Department of Planning & Infrastructure

NRE No 1 Colliery Project

Review of Surface Water Assessments

June 2013

Figure 2.1: Cataract Creek Wonga East Area 2 Stream Monitoring Sites

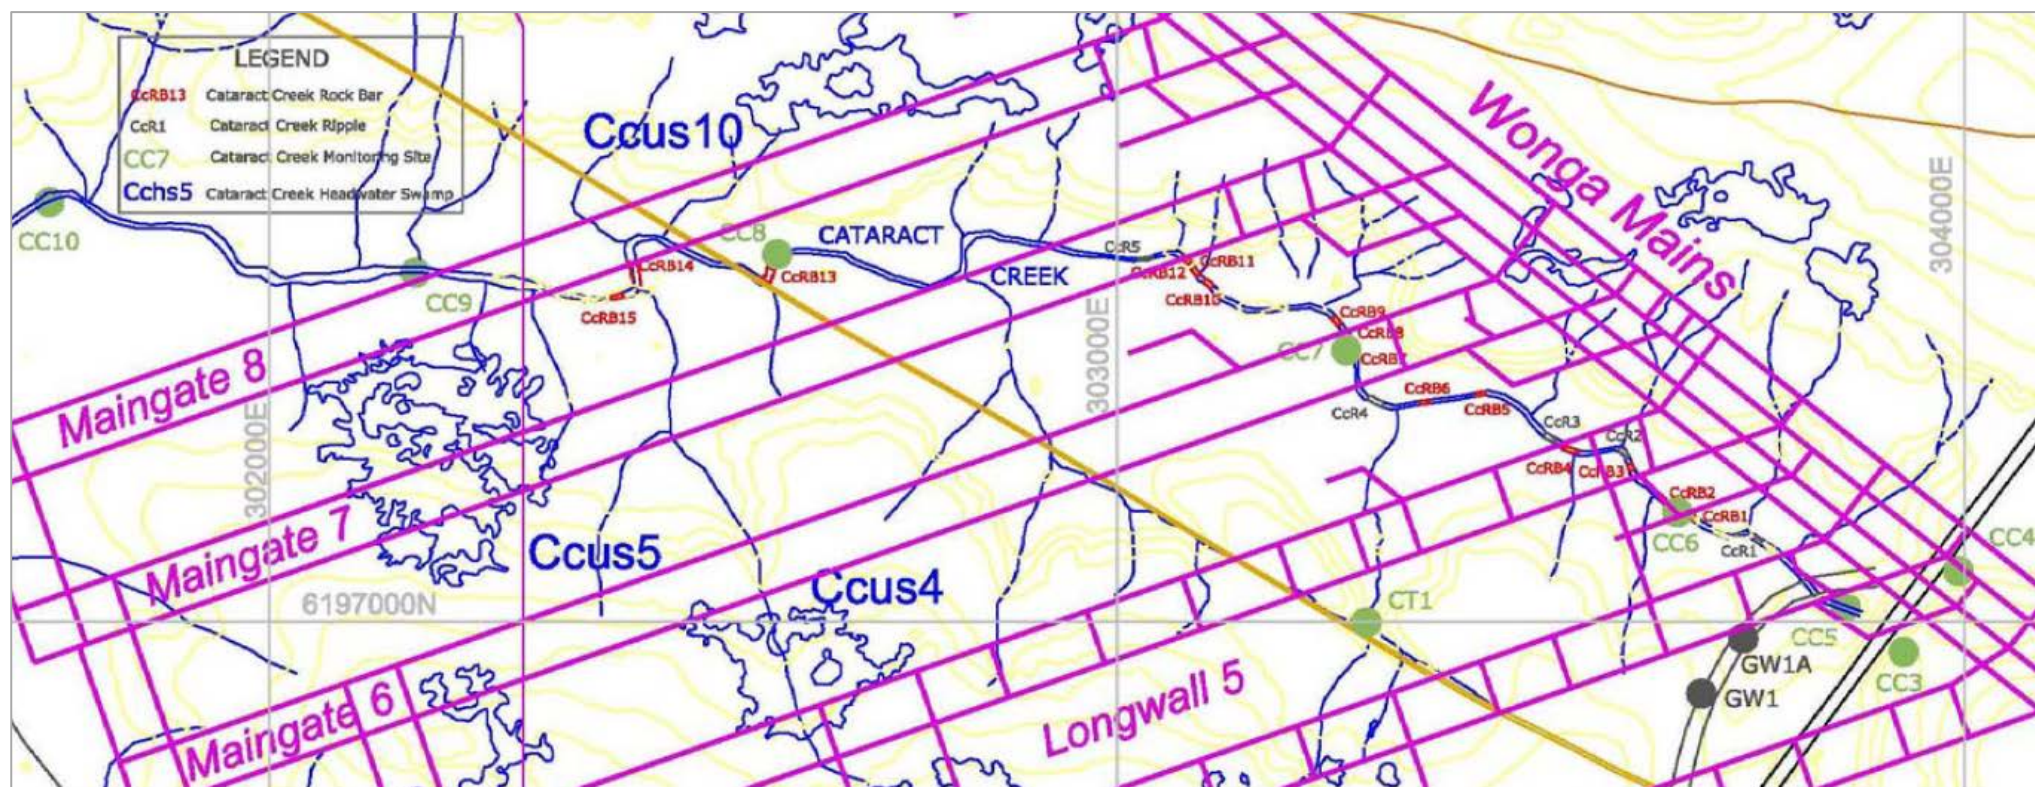
The figure would benefit from greater detail to show:

Whilst Figure 11 identifies the locations of the rock bars, the figure does not provide sufficient information regarding the size and importance of the various pools. It also appears that there is no intention to monitor the deeper pools listed as CcRB13 and CcRB14 which are located on the edge of Longwall 8 (and would apparently be at greater risk of cracking due to the strains).

In the Wonga East area all identified swamps are headwater swamps that are generally located in close proximity to the catchment divide. By reference to Figure 11 in the *Stream Assessment* report (copy in **Figure 2.1**), a significant number of small watercourses have been identified that, in most instances drain from the various headwater swamps. (This detail is not apparent on the 1:25,000 topographic maps or the drawings which use the photographic maps as a background). To assist in gaining an understanding of the relationship between the drainage network and the swamps it would be helpful for the level of detail depicted in Figure 11 (drainage lines, rock bars, riffle zones, etc.) to be provided on a map (or two) that encompass the whole of the Wonga East area and reproduced the colour coding for the swamp vegetation shown on Figures 4 and 5 in the *Upland Swamp Assessment*.

Figure 2.3: Mean Annual Rainfall Distribution
(Source: *Surface Water Modelling* report, Figure 4.4)

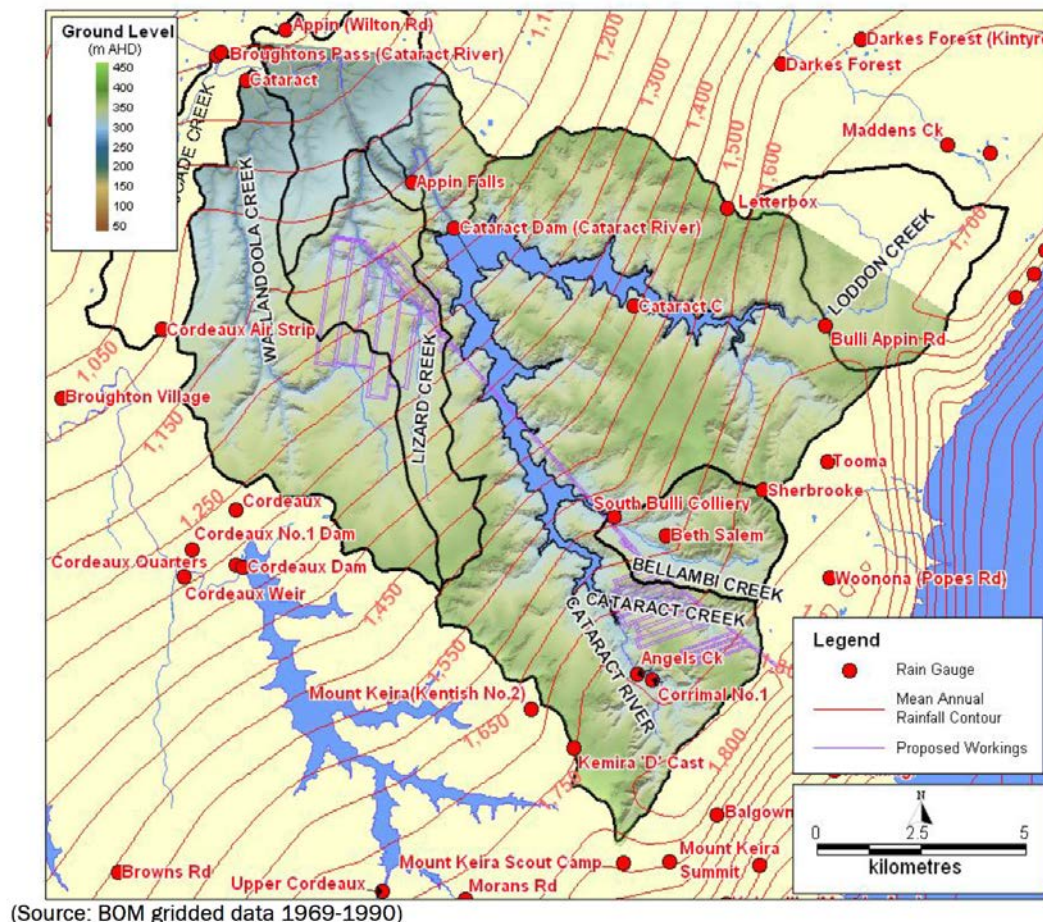
- The analysis in Appendix D uses monthly average rainfall for Picton. In view of the local rainfall variation (illustrated in **Figure 2.3** in this review), and as rainfall is a key factor in determining how much effluent can be irrigated, the use of Picton data requires justification.

Figure 2.4: Flow Duration Curves for Bellambi Creek and Loddon River
(Source: *Surface Water Modelling* report, Figures 6.8 and 6.10)

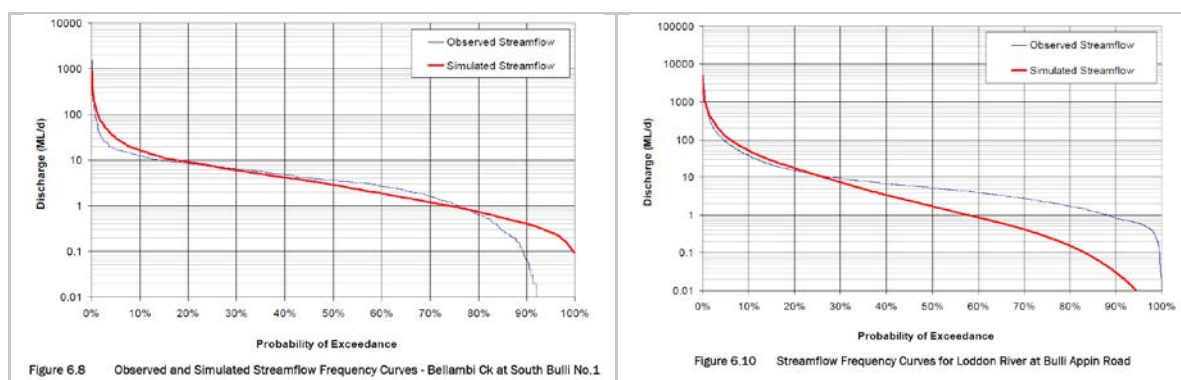
- **Figure 2.4** is a copy of the observed and modelled flow duration curves for Bellambi Creek and Loddon River for the respective model calibration periods. These flow duration curves indicate that:

- The model parameters derived for Bellambi Creek tend to over-estimate the low flows (<1 ML/day);
 - The model parameters derived for Loddon River tend to under-estimate the lower flow range (<10 ML/day).

Figure 2.5: Impact of Catchment Loss on Cataract Reservoir Dry Period Stored Water Volume
(Source: *Surface Water Modelling* report, Figure 7.3)

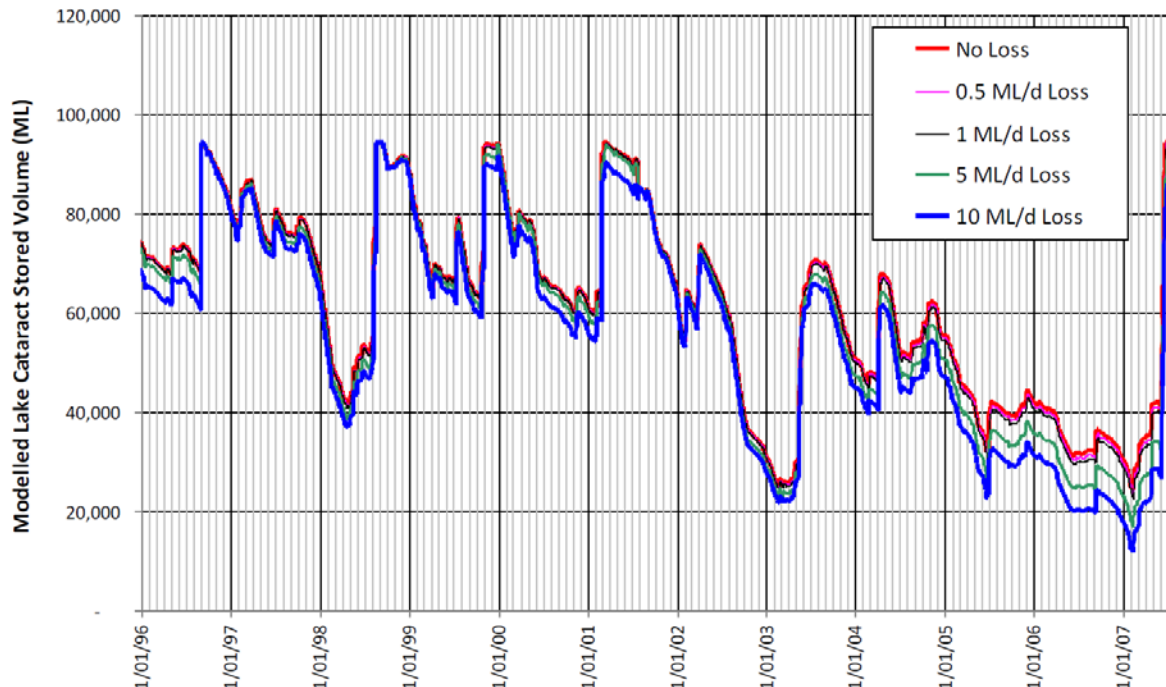
The assumed baseflow losses attributable to subsidence effects were 0.5, 1, 5 and 10 ML/day. These losses were assumed to be the combined effects of losses from Cataract Creek and Cataract River. Although not explained, it appears that the modelling assumed that the loss was subtracted from the combined total daily flow from Cataract Creek and Cataract River. This approach to sensitivity analysis appears reasonable. However, as noted above, there appears to have been some ‘modification’ to the modelled flow for higher flow events, which calls into question the validity of the modelling.

The modelling shows that maximum reduction in stored volume occurs in mid-2007 and ranges from 940 ML for a loss rate of 0.5 ML/day to 1,385 ML for a loss rate of 10 ML/day. The assessed minimal impact of this range of losses is hardly surprising given the fact that the catchments of Cataract Creek and Cataract River represent only 25% of the total catchment contributing to the

Figure 3.2: Impact of Losses on Flow Frequency Curve – Lizard Creek and Wallandoola Creek
(Source: *Surface Water Modelling* Report, Figure 7.5)

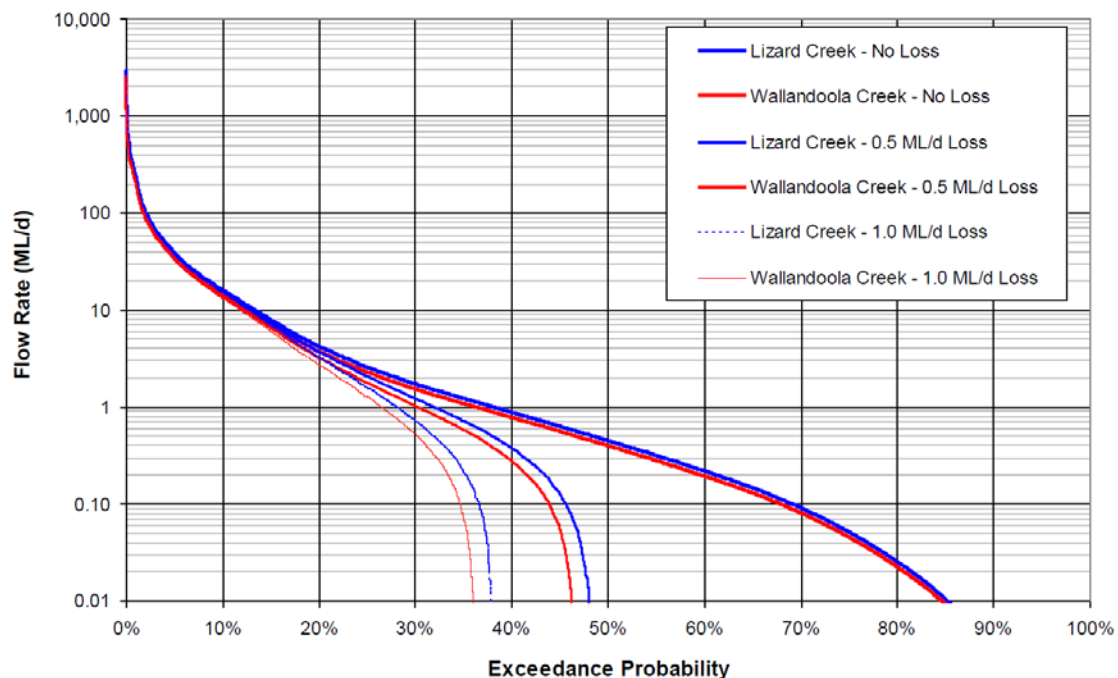
The report contains a discrepancy between the text describing the analysis (which lists flow losses of 1, 5 and 10 ML/day in Section 7.2.2) and the results (that refer to losses of 0.1 and 0.5 ML/day). From an inspection of the results (reproduced in **Figure 3.2**), it appears that the earlier reference to 1, 5 and 10 ML/day is a typographical error.

Note that these losses have been assessed for the creeks at the confluence with the Cataract River and are not directly comparable with the results in **Figure 3.2** and **Table 3.2** which relate to the downstream boundary of the 20 mm subsidence zone. Notwithstanding the differences in catchment area, the flow frequency results in **Figure 3.2** provide a useful basis for a more discriminating assessment of groundwater baseflow losses than is provided in the *Stream Assessment* which relates the losses to the average flow in each creek. While the groundwater baseflow losses represent a very minor loss as a percentage of the average flow (0.7% and 0.6% respectively), it can be seen that in respect of the flow regime shown in **Figure 3.2**, these losses would significantly affect the low flow regime in both creeks. This aspect has not been adequately assessed.

Figure 4.1: Catchment Designations within the Russel Vale Site
Source: Stormwater Hydrology Review

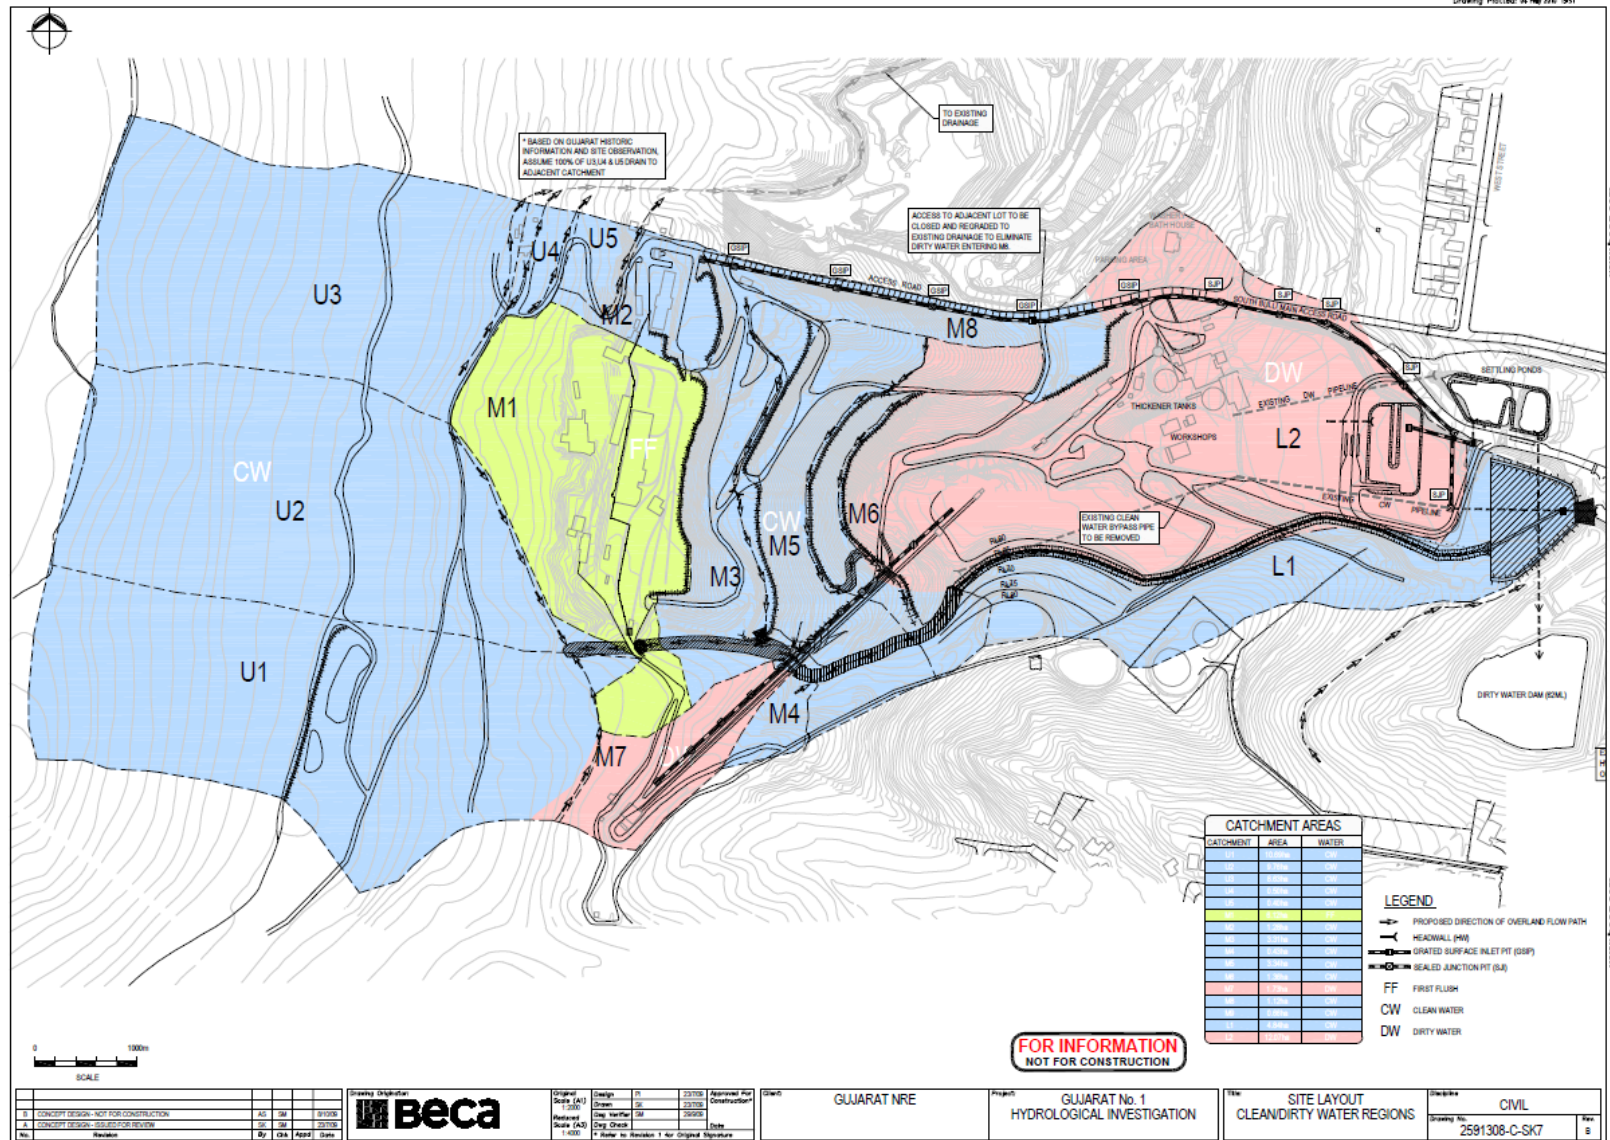
A number of aspects of the existing and proposed stormwater management systems require further clarification:

- The contention that the mine portal and pit-top area (including the workshop) (catchment M1) can be considered to have only moderate potential for generation of polluted stormwater is questionable. The proposed method of treatment of this water is via a first flush system that directs the initial runoff into the dirty water capture system and the remaining runoff to the Southern Stormwater Channel. Further details are required to:

Figure 4.2: Wonga East (27 Cut through) Groundwater Extraction and Rainfall
Source: *Groundwater Assessment* Figure 22

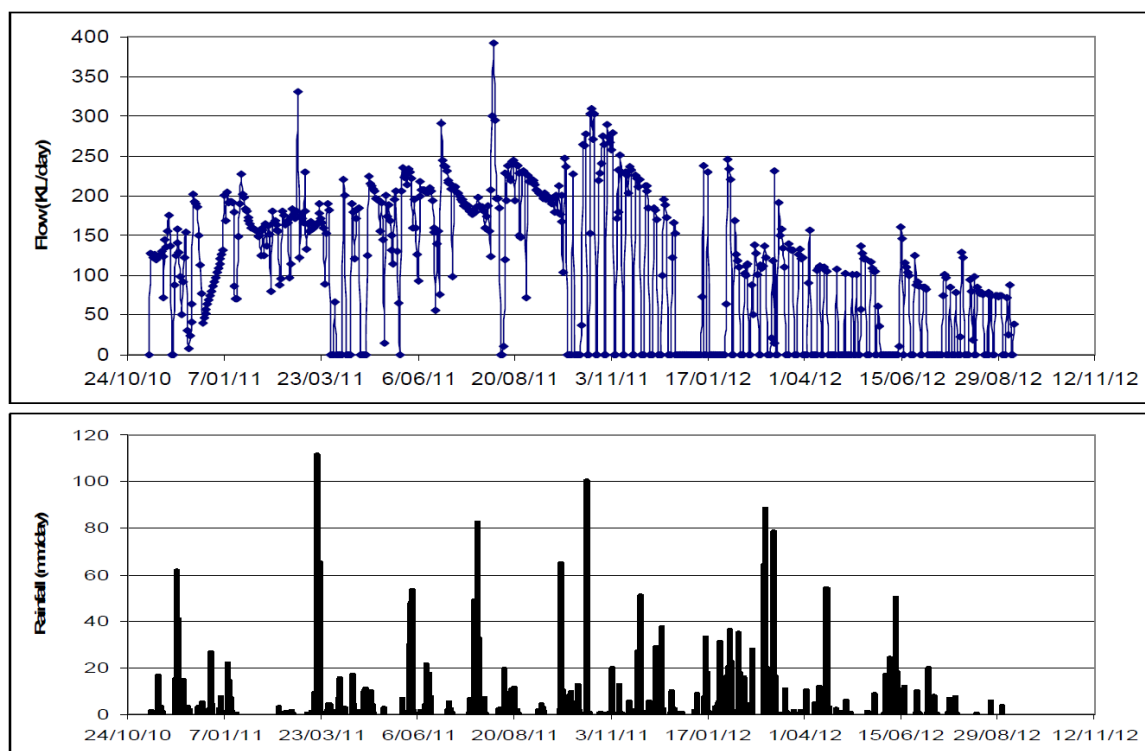
It is unclear how well the modelled groundwater inflow rates correlate with actual dewatering records from recent years. Figure 22 in the *Groundwater Assessment* (reproduced as **Figure 4.2** below) shows the pumping from one section of the workings which appears to show an average since 2010 of about 0.15 ML/day. Presumably there are other pumping records that could be used to support the estimates of current groundwater inflow.

One of the objectives of the graphs in Figure 22 of the *Groundwater Assessment* appears to be to demonstrate that there is no relationship between rainfall and groundwater make. The assertion that there is no relationship would be more apparent if the rainfall and inflow graphs were plotted as cumulative values against each other.
